**[Issue No.]** T99-0015

**[Title]** Notice on Upgrade of Software Package for  
CC-Link Interface Board  
and PLC CPU Board for Personal Computer

**[Date of Issue]** Dec. '00

**[Relevant Models]** A80BDE-J61BT11, A80BDE-J61BT13, A80BDE-A2USH-S1

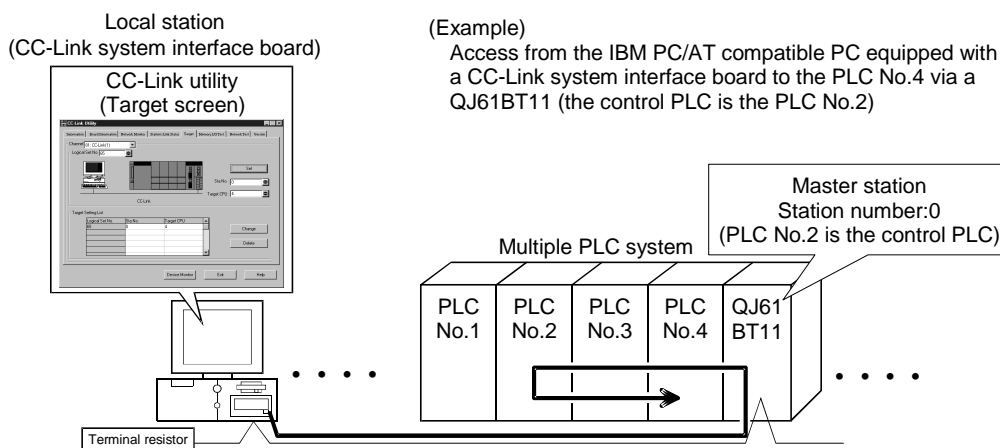
- **Compatible with Microsoft Windows 2000 Professional Operating System (CC-Link system interface board, PLC CPU board)**

The CC-Link system interface board and the PLC CPU board are compatible with the Microsoft Windows 2000 Professional Operating System.

Since neither Microsoft Visual Basic 5.0 nor Microsoft Visual C++ 5.0 are available with the Microsoft Windows 2000 Professional Operating System, either Microsoft Visual Basic 6.0 or Microsoft Visual C++ 6.0 is necessary for creation of user applications.
